SEWAGE DISPOSAL SYSTEM

MARYLAND STATE DEPARTMENT OF HEALTH

SUBDIVISION Mill Lica 3460 Higley Mill Rd. LOT 4

MAP OF
MILL GREEN
SECTION ONE
LOT 4
HOWARD COUNTY, MARYLAND

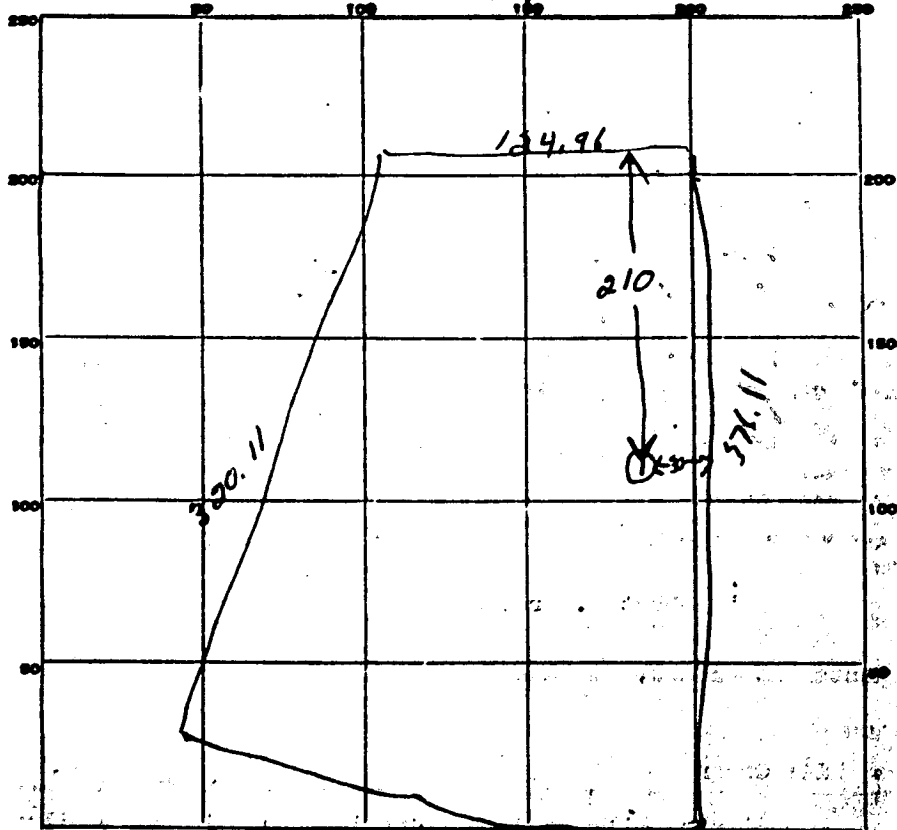
REMARKS 10/2/63 - System has ^{over} 1 1/2 ft gravel around dry well - giving diameter of
over 4 ft - no problem - OK - 3572 y p

LOCATION DRAWING

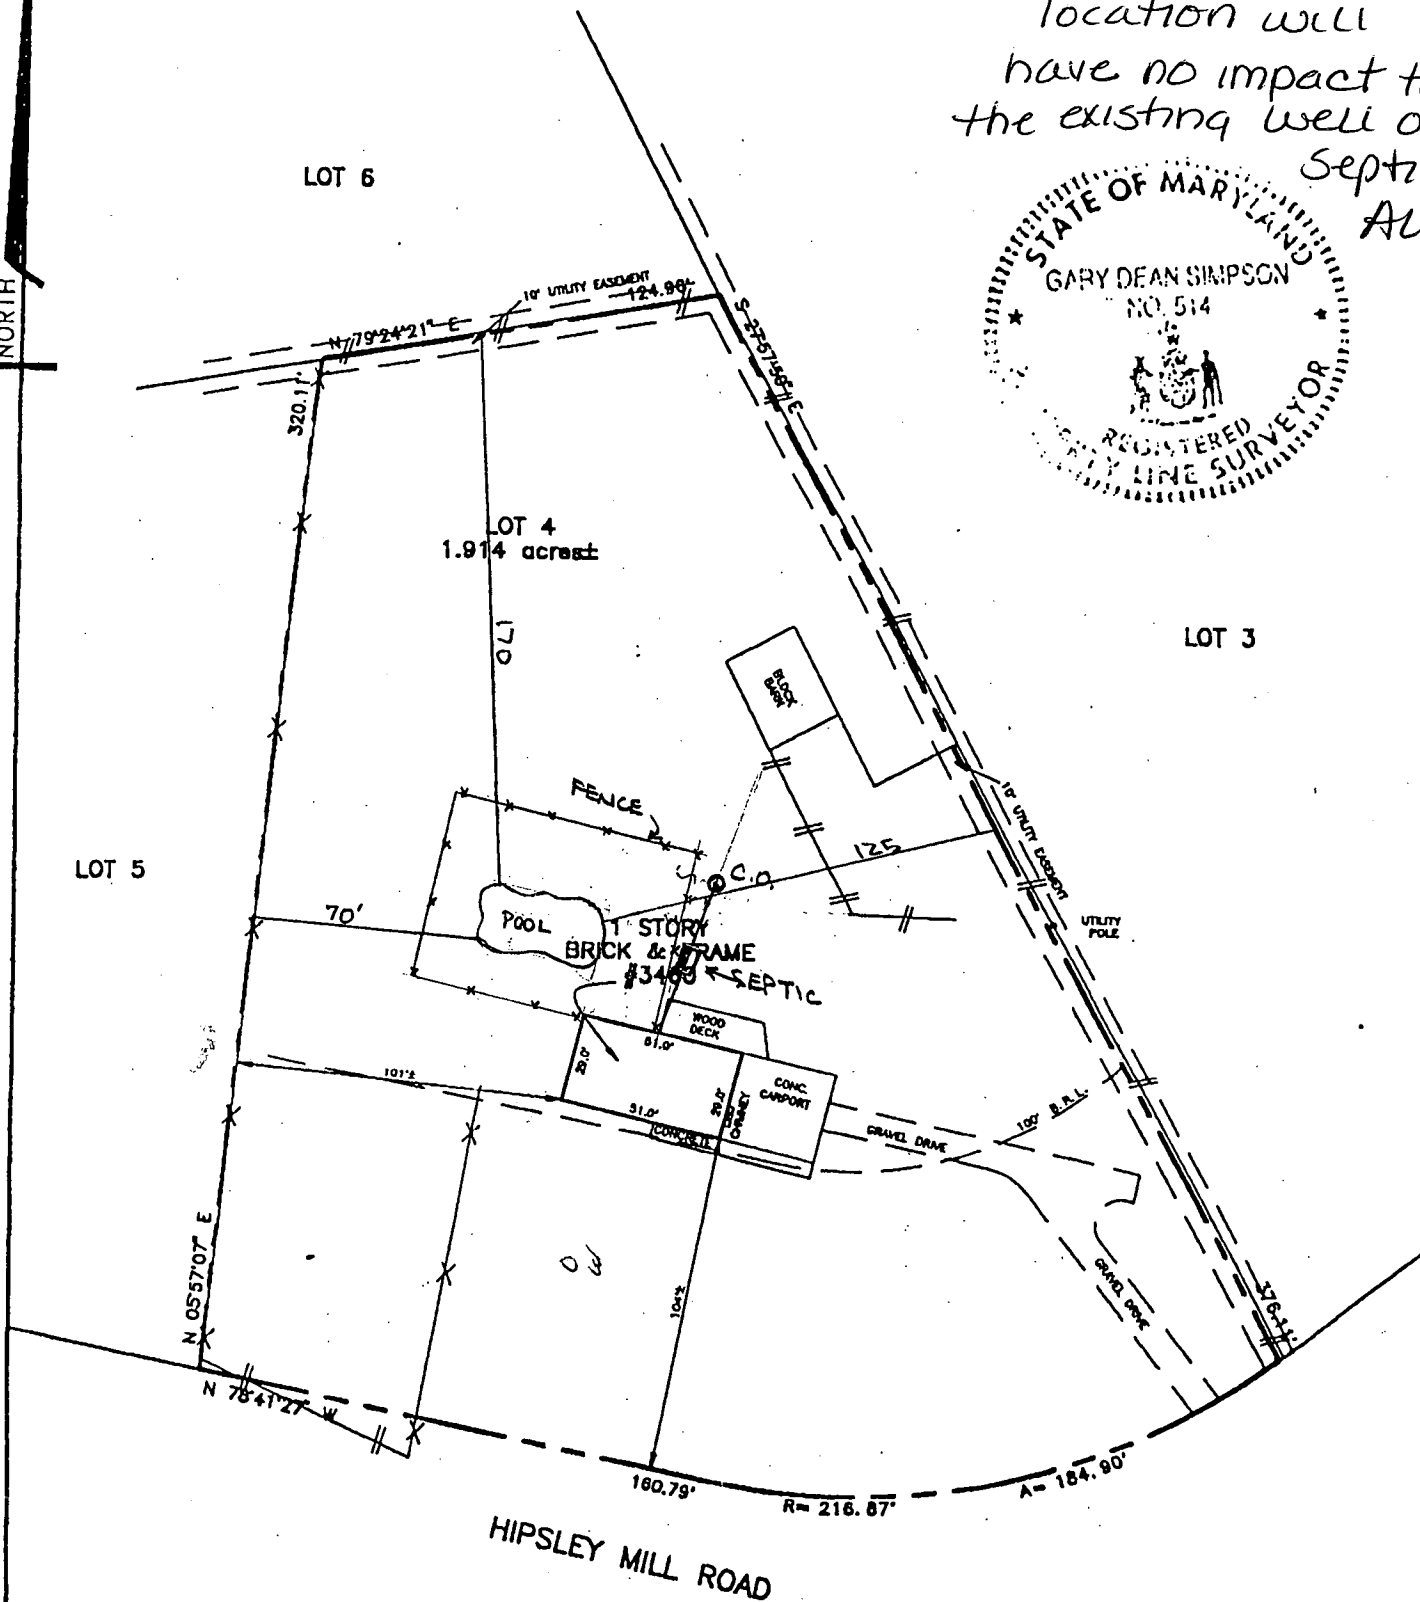
5/21/97
Shown pool
location will
have no impact to
the existing well or
Septic
AU
